National Committee on Uniform Traffic Control Devices

Attachment No.: 14
Item No.: 18-BIK-06
BTC version v0.4

NCUTCD Proposal for Changes to the Manual on Uniform Traffic Control Devices

TECHNICAL COMMITTEE: Bicycle Technical Committee
ITEM NUMBER: 18-BIK-06
TOPIC: Bicycle Detector Symbol Marking
ORIGIN OF REQUEST: NCUTCD Bicycle Technical Committee
AFFECTED SECTIONS OF MUTCD: Sections 9C.05

Figure 9C-7. Bicycle Detector Pavement Marking
[Replace the existing symbol with:]

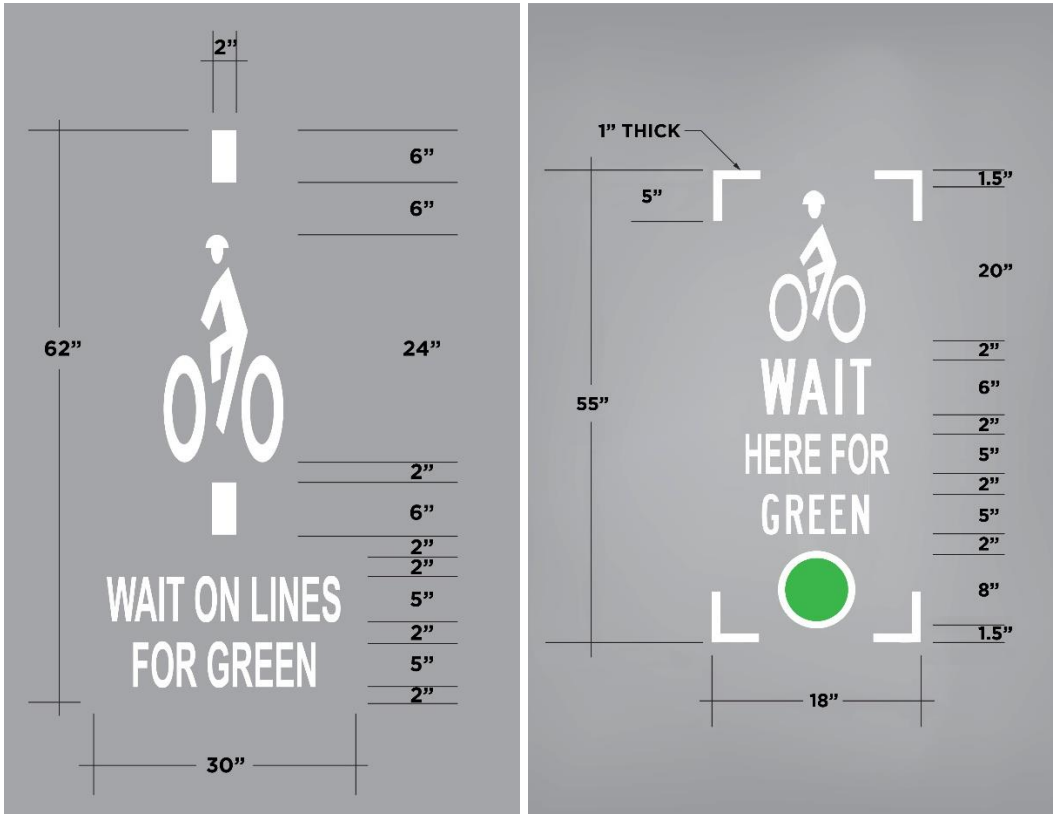
This proposal adds explanatory text to the existing Section 9C.05/Figure 9C-7 Bicycle Detector Pavement Marking Symbol to modify the existing marking and adds an optional marking developed via a Request To Experiment (RTE) “9(09)-66E Bicycle Detector Pavement Marking Alternatives – Columbia, MO” approved by FHWA On September 19, 2014. Both symbols had a much higher user comprehension than the original symbol even when the original was accompanied by the Section 9B.13 Bicycle Signal Actuation Sign (R10-22) that interprets the existing symbol.

- 49 • Participants in the MU simulator test preferred the proposed alternate by 96% to 19% for
50 the existing MUTCD 9C-7 symbol.
- 51 • In the Columbia field test, 253 individuals responded to a survey after the proposed
52 markings were installed at four intersections. Only 12% of responders correctly identified
53 the purpose of the MUTCD 9C-7 symbol, while 87% identified the proposed symbol as
54 “Bikes stop here for green light”

- 55 • During this experiment, an additional study was completed in Portland, OR that
56 confirmed the preference for the “Columbia Experiment” marking over the existing 9C-7
57 symbol. Five symbol configurations including the MUTCD 9C-7 symbol were evaluated
58 via field testing and surveys. Participants were asked to rank the symbols in preference
59 as to how well the symbol communicated its purpose. The Columbia experiment symbol
60 was ranked first by a wide margin in communicating the location where a bicyclist should
61 stop in order for a signal to detect the bicyclist. During the test, Portland also tested
62 recognition of the 9C-7 symbol with the added text “WAIT ON LINES FOR GREEN”.
63 This combination had a very high level of comprehension when the text was added.

79 01 A symbol (see Figure 9C-7A or 9C-7B) may be placed on the pavement indicating the
80 optimum position for a bicyclist to actuate the signal.
